SPECIAL DESIGN

CULVERT

<b>DEPARTMENT OF HIGHWAYS - ONTARIO</b> <b>MATERIALS &amp; RESEARCH DIVISION - FOUNDATION SECTION</b>			
<h2 style="margin: 0;">CULVERT INVESTIGATION</h2> <p style="margin: 5px 0 0 0;">(NORTH OF GODERICH)</p>			
KING'S HIGHWAY NO. <u>21</u>		DIST. NO. <u>3</u>	
CO. <u>HURON</u>		LOT <u>6</u>	
TWP. <u>COLBOURNE</u>		CON. _____	
<b>SUB - SOIL STRATIGRAPHY</b>			
SUBMIT:	CHECKED	W.R. NO. <u>213-60</u>	M & R. DRAWING NO.
DRAWN F.C.	CHECKED <u>...</u>	JOB NO. <u>61-F-53</u>	<b>61-F-53B</b>
DATE <u>NOV. 6, 1963</u>		SITE NO.	BRIDGE DRAWING NO.
APPROVED <u>[Signature]</u>		CONT. NO.

Work Project 213-60 - Highway #21 North of Goderich  
Construction of Dam

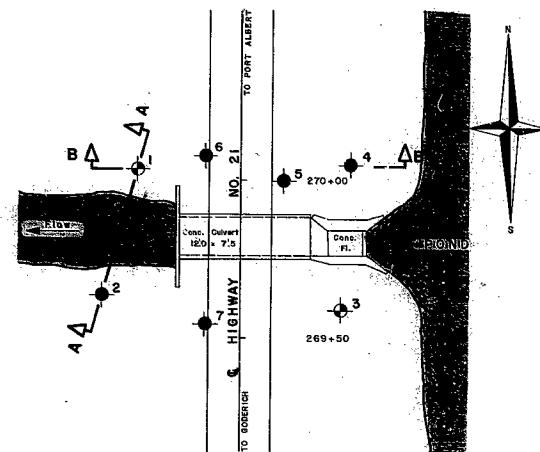
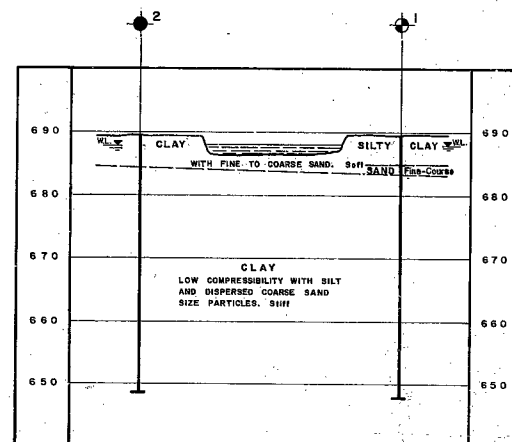
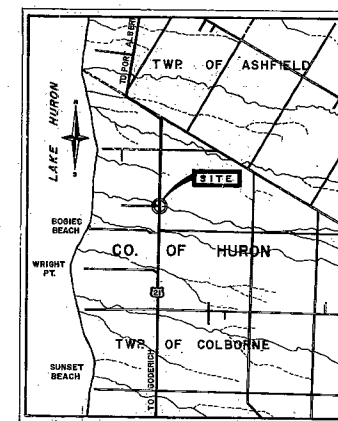
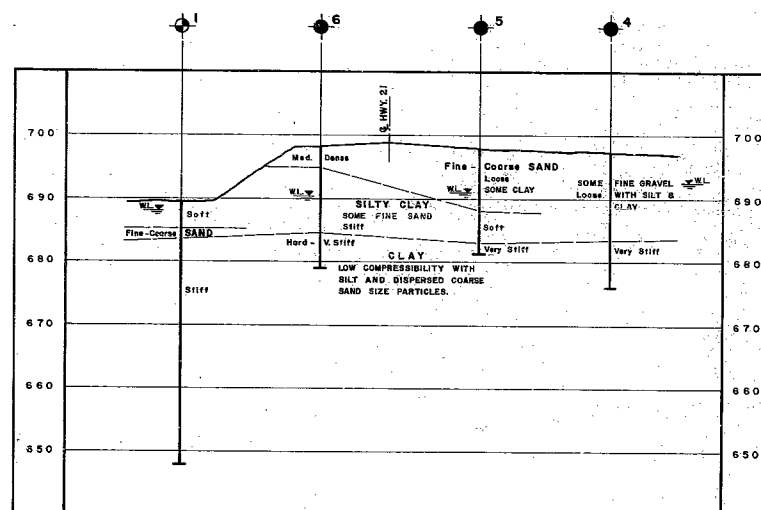
Dewatering will be a problem and the footing excavation must be kept dry. This may be achieved by driving sheet piling approximately one foot into the underlying stiff to very stiff silty clay with dispersed sand (See Drawing 61-F-53A), and using a sump pump.

7.2) Spread footings with a safe bearing load of 2 T/ft.<sup>2</sup> may be placed at an elevation of 683.5' or lower in the very stiff to stiff silty clay layer indicated in Drawing 61-P-53A.
